**INDIANA
MICHIGAN
POWER®**

Donald C. Cook Nuclear Plant Units 1 and 2
Proposed Risk-Informed Inservice Inspection Program
Request for Additional Information (TAC Nos. MD3137 and MD3138)

Attachment to AEP:NRC:7055-03

Risk-Informed Inservice Inspection Program
Request for Additional Information

Typical Inspection Regions

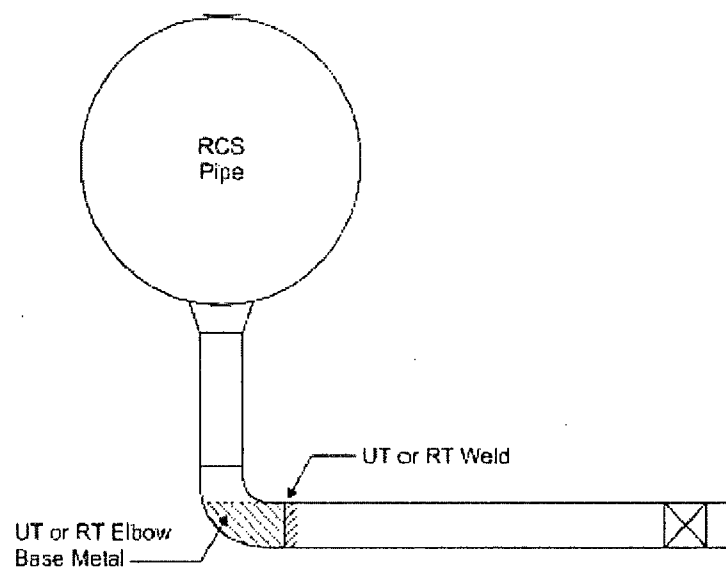
Please describe how volumetric examinations will be performed. At a minimum, will volumetric examinations include the volume required for ASME Section XI examinations? Will ASME Section XI, Appendix VIII qualified examiners and procedures be used for all volumetric exams? Will the examination volume be scanned for both axial and transverse indications for all exams? Please describe and justify your answers.

I&M Response to Request 3

Volumetric examinations will be performed as required by Table 1 of N-716. The table requires an examination volume as defined in the ASME Code Section XI IWB figures. This would require examination of at least the ASME Code Section XI volume (more volume may be required based on the notes on Table 1 of N-716). N-716 does not take any exceptions to the paragraphs of ASME Code Section XI that govern volumetric examinations and I&M's proposed alternative request does not take exception to any 10 CFR limitations. Therefore, I&M will examine these welds using the same personnel and procedure requirements as a traditional ASME Code Section XI piping volumetric examination.
